# ARCHITECT'S SUPPLEMENTAL INSTRUCTIONS

Date Issued:	May 19, 2020
Project:	Intermountain Healthcare  Tooele Valley Dialysis Clinic Expansion 2356 North 400 East, Suite #102 Tooele, Utah 84074
Architect's Supplemental Instructions:	ASI #6
To:	Saunders Construction 1113 South 500 West Bountiful, Utah 84010

RE: ASI-006 - Existing Waste Drops from Level 2

PP100

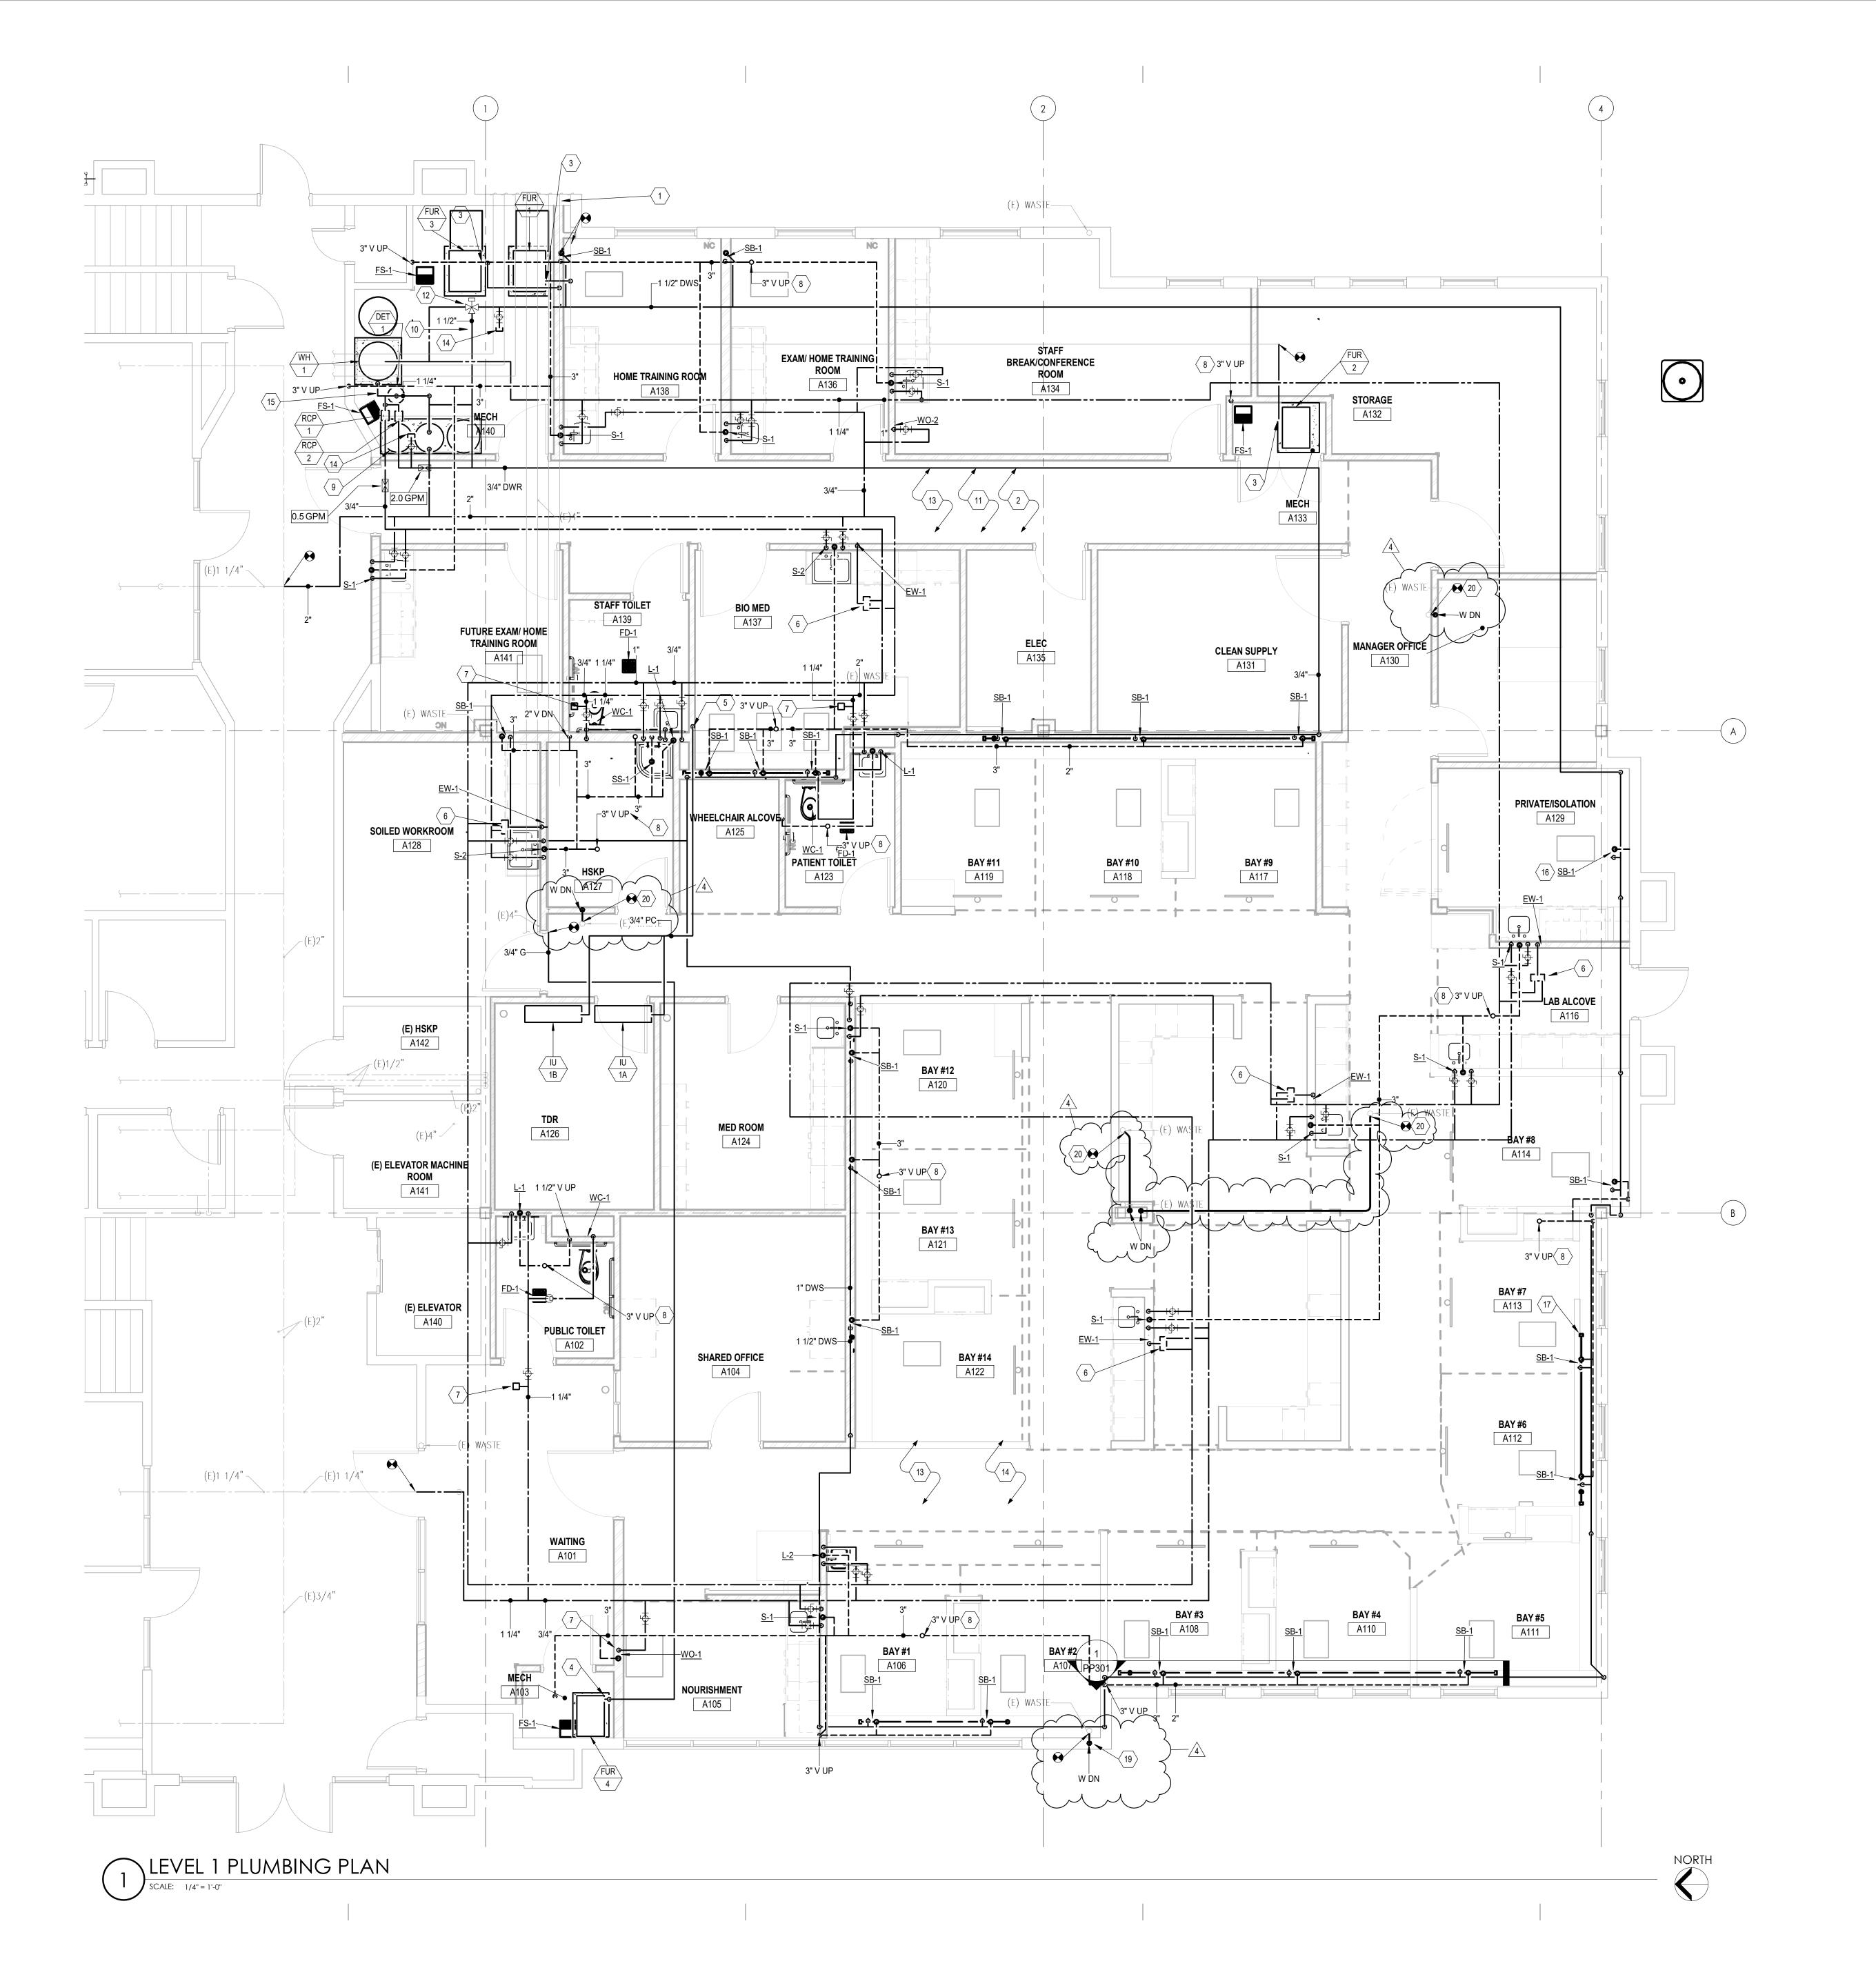
### SHEET - PP100 - BELOW GRADE PLUMBING PLAN

- 1. Existing drops not shown on existing drawings added.
- 2. New drops and routing to existing drops added.
- 3. Keyed note 4 added.
- 4. Keyed note 5 added.
- 5. Keyed note 6 added.

5. FLOOR CUT FOR EXISTING WASTE DROP. TIE INTO NEAREST WASTE LINE.

6. FLOOR CUT TO TIE INTO EXISTING DROP LOCATIONS.
